Tractive GmbH Poststrasse 4, 4061 Pasching, AUSTRIA

Class II Permissive Change Letter

FCC ID Certification No.: 2AVE6TG4XL

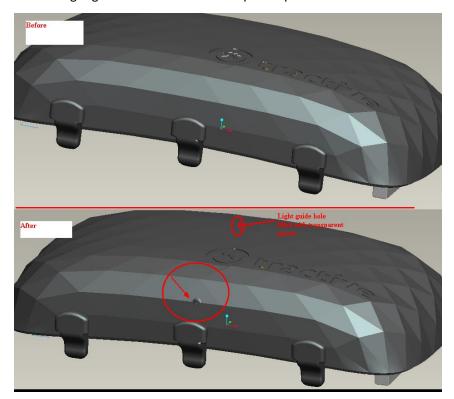
a. Remove buzzer and two buzzer contact plates, add new buzzer FPC and add new magnetic buzzer on FPC

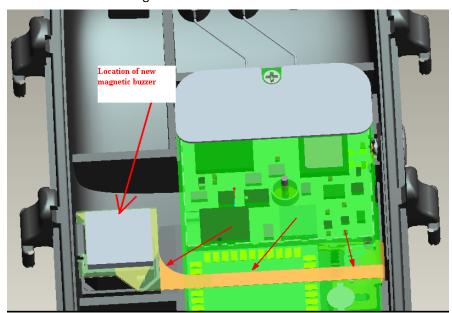
b. Add light guide hole filled with transparent plastic and one extra hole on Top case

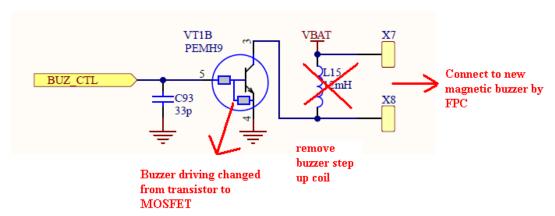
c. Location of new magnetic buzzer
